R44

SERVICE BULLETIN SB-53

SUBJECT: C046-18 Frame Tube

COMPLIANCE PROCEDURE: (Refer to figure on page 2)

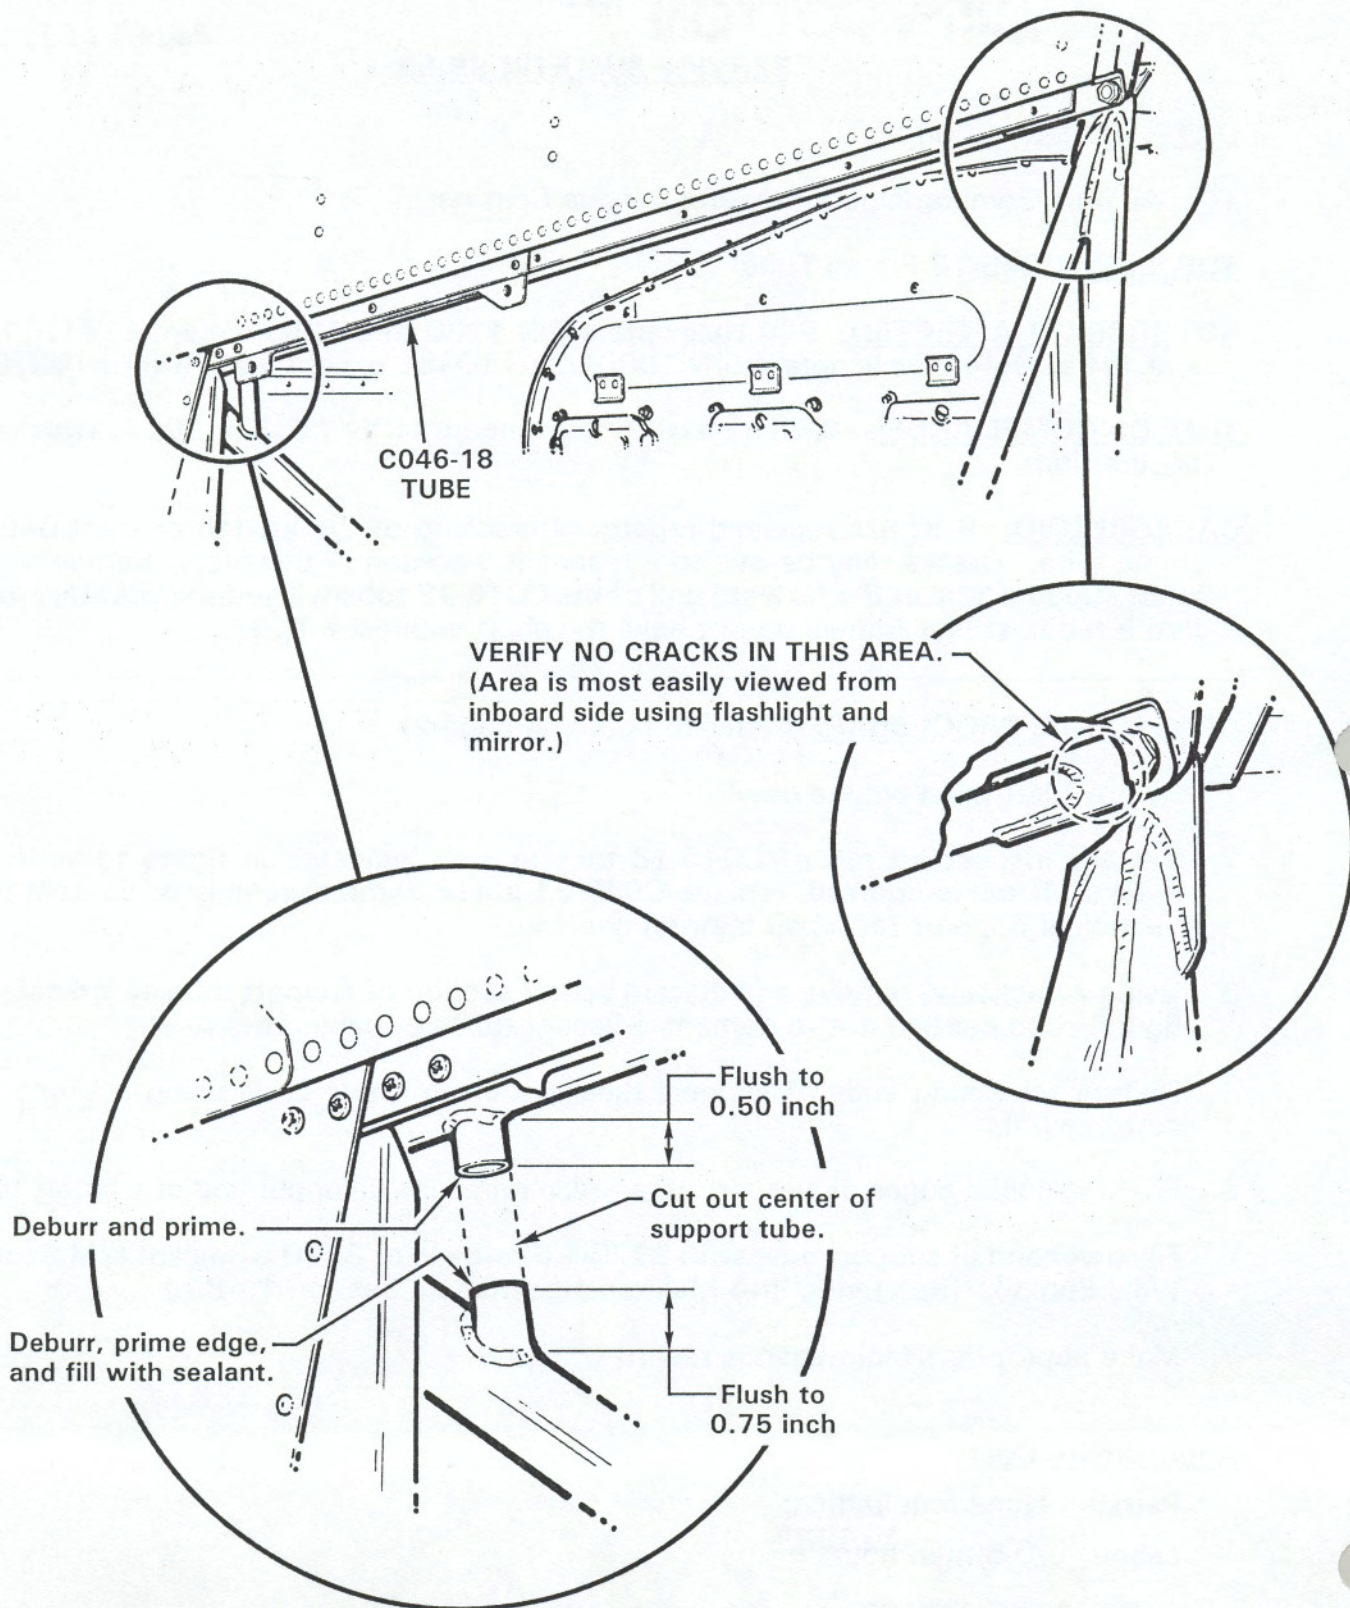
BACKGROUND: RHC has received reports of cracking of the aft tab of the C046-18 frame tube. Cracks may be due to a resonant vibration in the tube. Removing the short support tube at the forward end of the C046-18 tube will reduce vibratory loads in the tube. (Older frames do not have the short support tube.)

1. Remove left-hand engine cowl.
2. Visually inspect aft tab of C046-18 tube in area indicated in figure to verify no cracks. If tab is cracked, replace C046-21 lower frame assembly or contact RHC Technical Support for repair instructions.
3. Using a hacksaw, remove and discard center section of support tube as indicated in figure. Use caution not to damage adjacent tubes or cabin structure.
4. De-burr remaining ends of support tube and clean inside ends using acetone and cotton swab.
5. Prime exposed edges of support tube. Also prime inside upper end of support tube.
6. Fill lower end of support tube with B270-1 (Pro-Seal) or B270-9 sealant (3M Scotch-Weld Epoxy). (Reference R44 Maintenance Manual Section 1.480.)
7. Make appropriate maintenance record entries.
